Section 16 Planning Application for Proposed Minor Relaxation of Building Height Restriction for Permitted Flat Use at TMTL 569, Tuen Mun, New Territories (Application No. A/TM/604)

Updated Planning Statement

Response to Comments and Supporting Attachments

Updated Photomontages

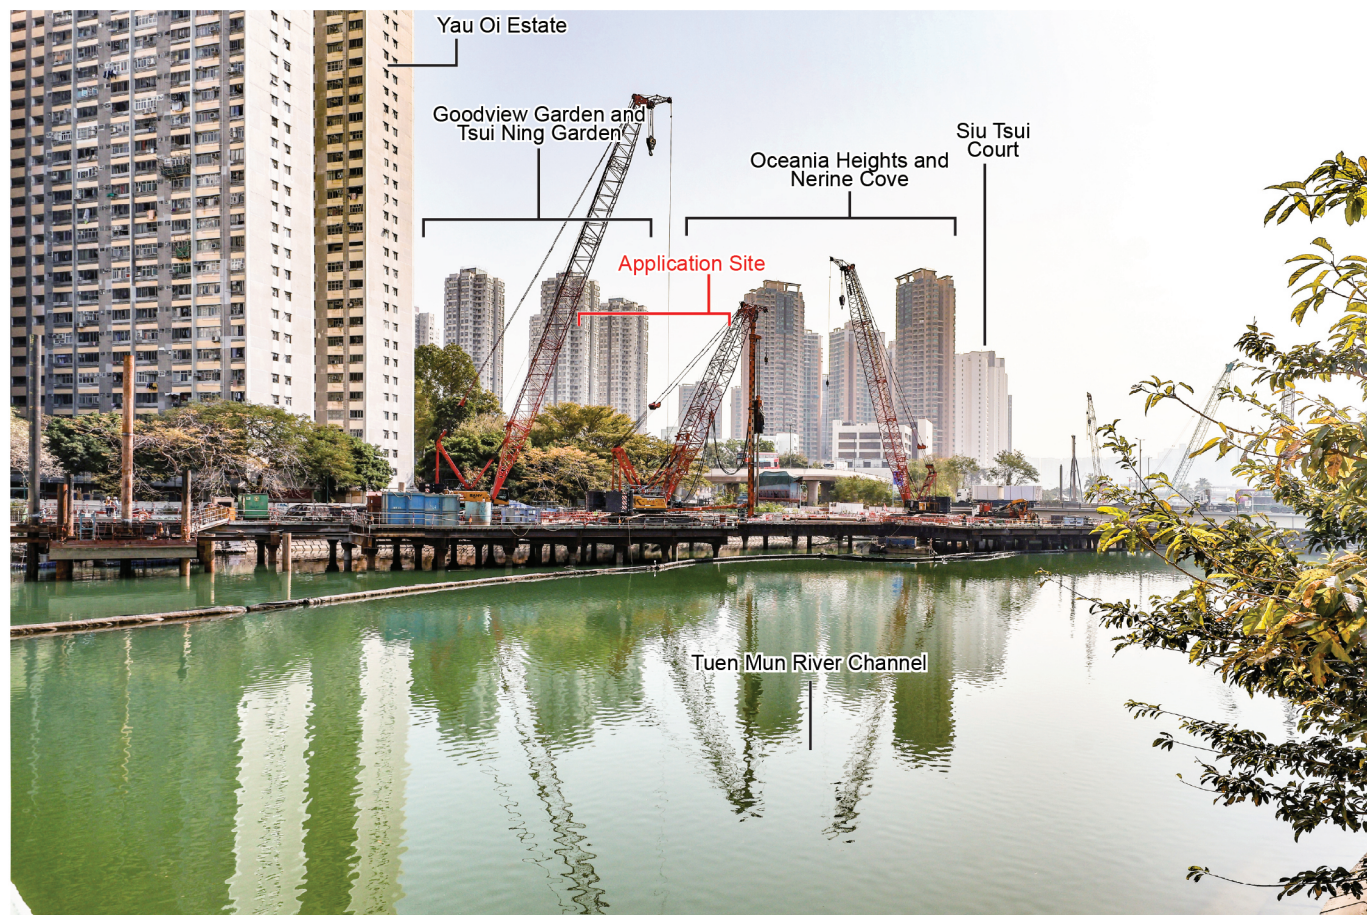
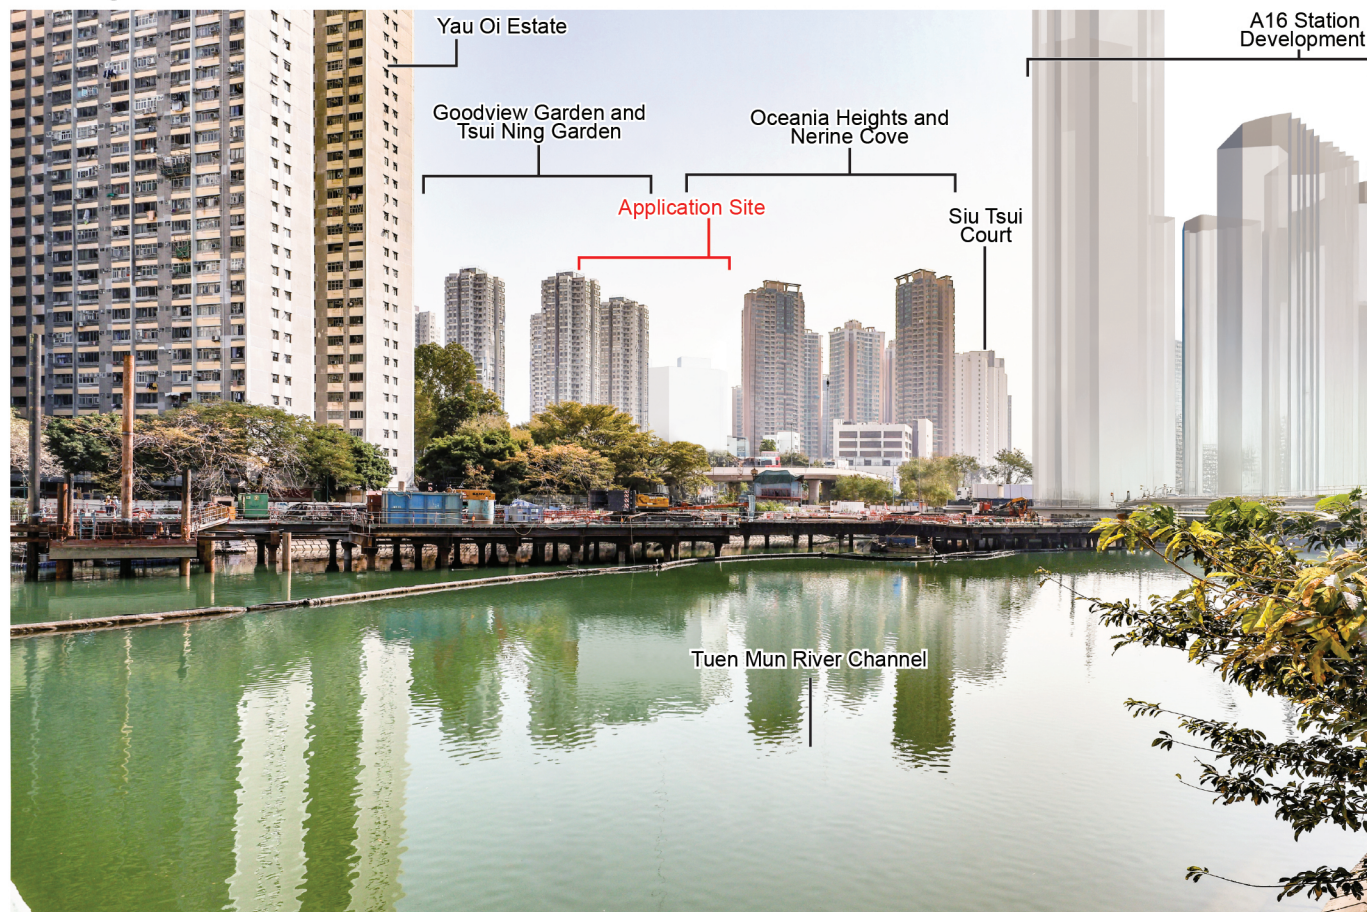
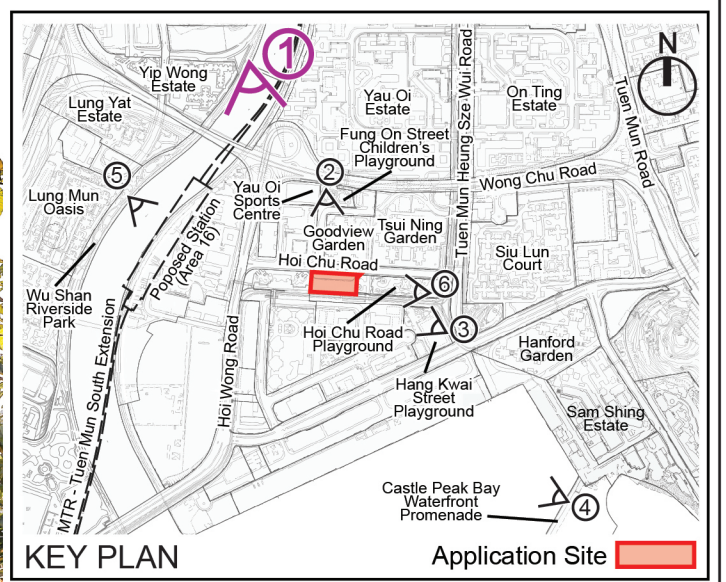
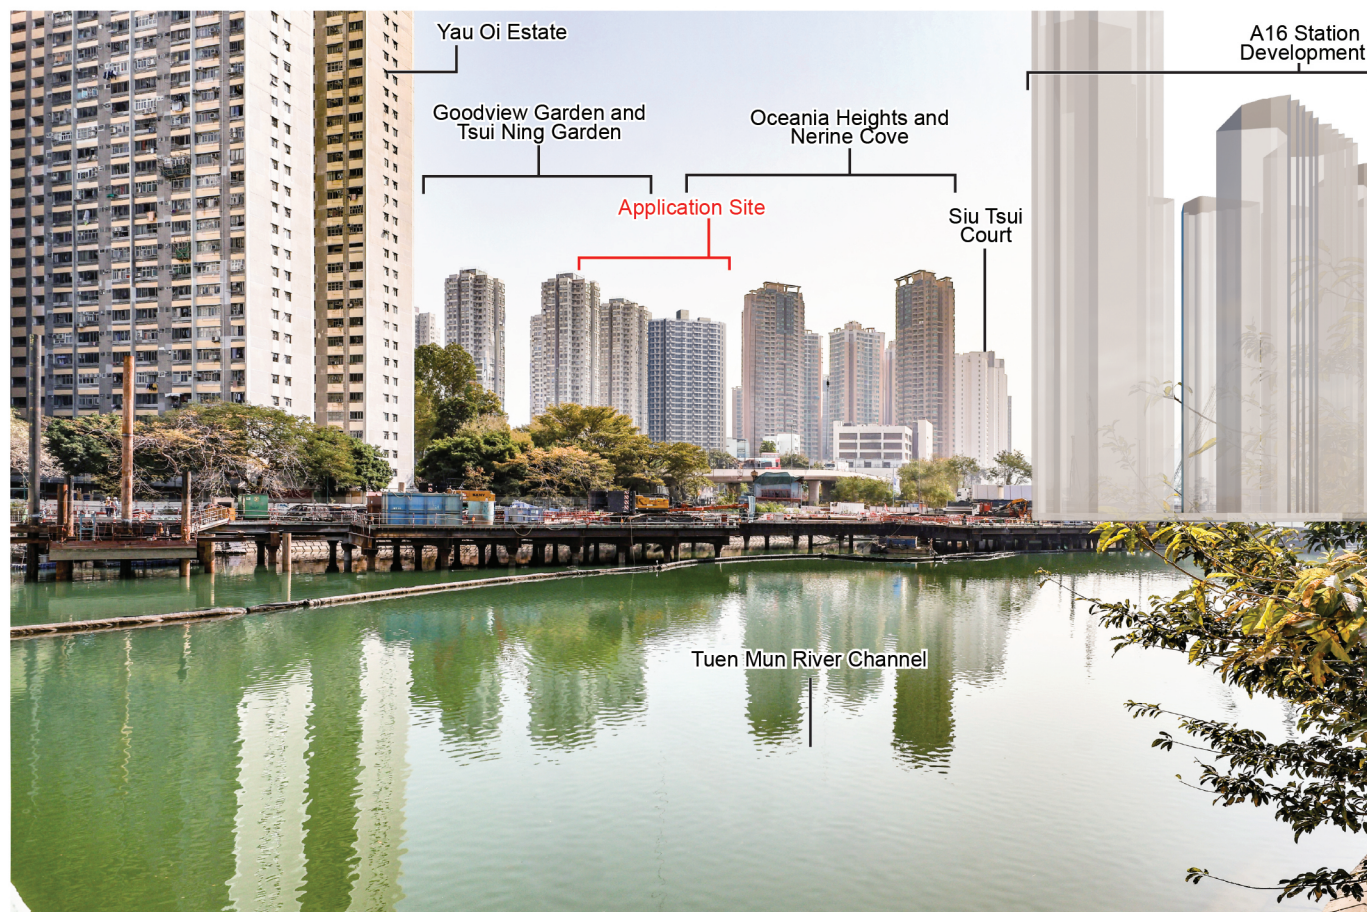
2.4	<p>VP 1 (figure 4.1) – the proposed development appears to be taller (i.e. appears to be level with Goodview Garden) and half of the proposed development should be screened by Goodview Garden and Tsui Ning Garden at the foreground in the photomontage. In view of the slight visual obstruction to the open sky view, the overall visual impact of VP1 should be <u>Slight</u> instead of <u>Negligible / slight</u>.</p>	<p>Under the current updated scheme, the proposed building height will be reduced from 117.6mPD to 109.2mPD. At VP1, the proposed development will have a comparable height as the adjacent building cluster. A majority portion of the proposed development would also be screened by Goodview Garden and Tsui Ning Garden at the foreground. The overall visual impact of VP1 has been amended to slight.</p>

2.5	<p>VP 2 (para 4.2.9 and figure 4.2) – in view that the VP represents public viewers at an open space with high usage and its relative close proximity to the Site, the visual sensitivity should be <u>High</u>. With reference to the photomontage, the proposed development will slightly obstruct the open sky, the rating of overall visual impact of VP2 should be <u>Slight</u> instead of <u>Negligible</u>.</p>	<p>Under the current updated scheme, the proposed building height will be reduced from 117.6mPD to 109.2mPD. At VP2, only a very minor portion of the proposed development would obstruct the open sky. The overall visual impact of VP2 has been amended to slight.</p>

Departmental Comments	Responses to Comments
2.6	<p>VP 3 (para 4.2.10 and figure 4.3) – the proposed development appears to be taller (i.e. taller than Goodview Garden). As the VP represents public viewers at an open space with high visibility of the proposed development, the visual sensitivity should be as “High”. Explanation has not been provided as to why a more direct open space adjacent to the proposed development has not been chosen for the VA.</p>	<p>An additional VP as viewing from the open space adjacent to the proposed development has been included. Please refer to Attachment D – Updated Photomontages for consideration. The Visual Appraisal has also been updated accordingly. Please refer to Enclosure A – Updated Planning Statement of this Supplementary Submission for consideration.</p>
